SUBJECT: Forwards revised FSAR pages describing jet area based on target location to replace Page 3.6-46.

Subject: NUCLEAR PROJECT NO. 2
WNP-2 JET IMPINGEMENT ANALYSIS METHODOLOGY

Attachment to P. 3.6-46

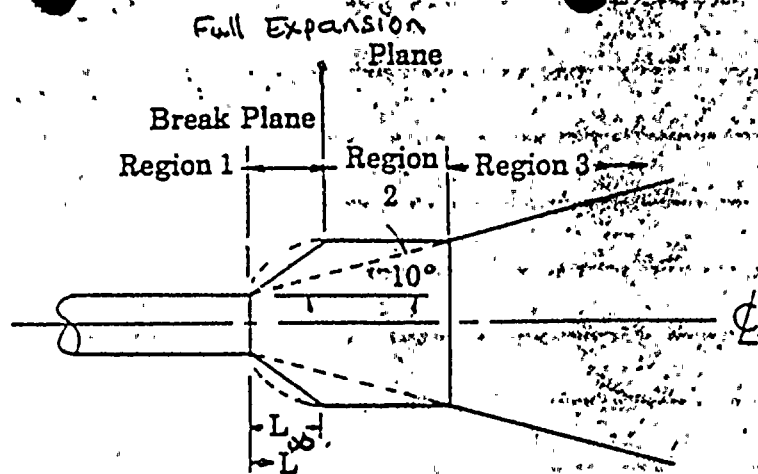
~~For $L_T < L_\infty$~~

Add Attachment As Shown

In Region 2: for $L_{\infty} \leq L_T < \frac{1}{2} \left[\sqrt{\frac{4A_{\infty}}{\pi}} - D_E \right] \cot 10^\circ$,

$$L_3 = \frac{1}{2} \left[\left(\frac{4A_{\infty}}{\pi} \right)^{1/2} - D_E \right] \cot 10^\circ$$

In Region 3: for $\frac{1}{2} \left[\sqrt{\frac{4A_{\infty}}{\pi}} - D_E \right] \cot 10^\circ < L_T < \infty$

$$A_L = A_E \left(1 + \frac{2L}{D_E} \tan 10^\circ \right)^2 \quad (\text{Eq. 3.6.2.3.1-11})$$

$$A_L = A_E \quad (\text{Eq. 3.6.2.3.1-12})$$

Figure 3.6-3

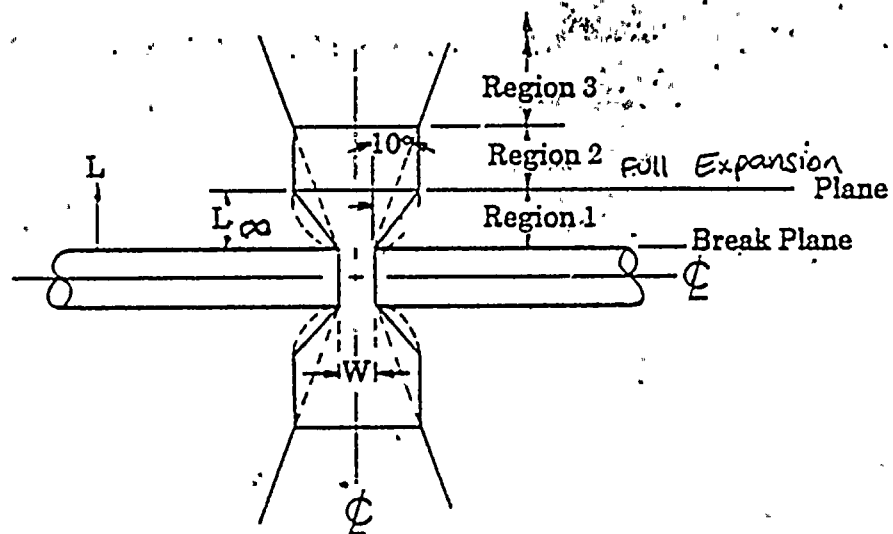
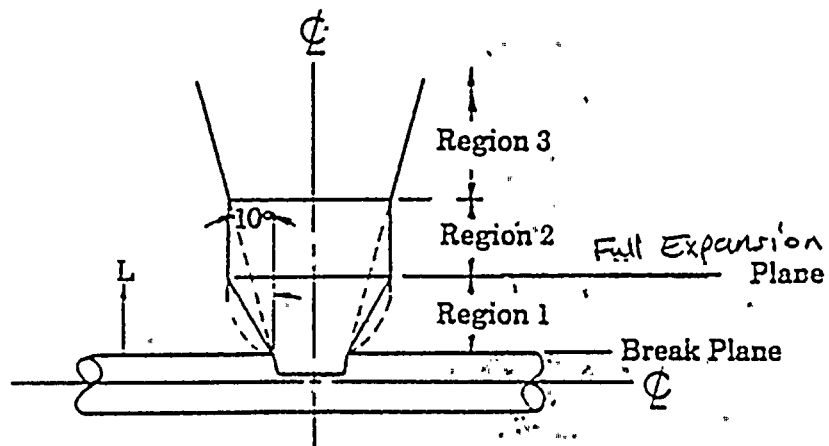
Revised FSAR pages describing the jet area based on target location are attached. These pages will replace the current page 3.6-46 of the FSAR. The jet area description follows the guidance of paragraph C2 of Appendix C, ANSI 58.2-1980. Please note that for non-flashing subcooled jets Equation 3.6.2.3.1-12 now specifies the jet area to be taken equal to the break area. As discussed in our phone conversation of February 12, 1982, subcooled jets have been first considered to expand at a 10° half-angle and any target within this cone is assumed to fail. Similarly for steam-water (i.e., flashing) jets any target within the theoretical jet envelop (see Appendix C of ANSI 58.2) is postulated to fail, regardless of the fact that the asymptotic plane location may exceed five (5) pipe diameters from the jet exit (see SRP 3.6.2, Section III, 3.(f)).

Replace with
Attached Figure 3.6-3

(A) Circumferential Break With Full Separation

(B) Circumferential Break With Partial Separation

(C) Longitudinal Break
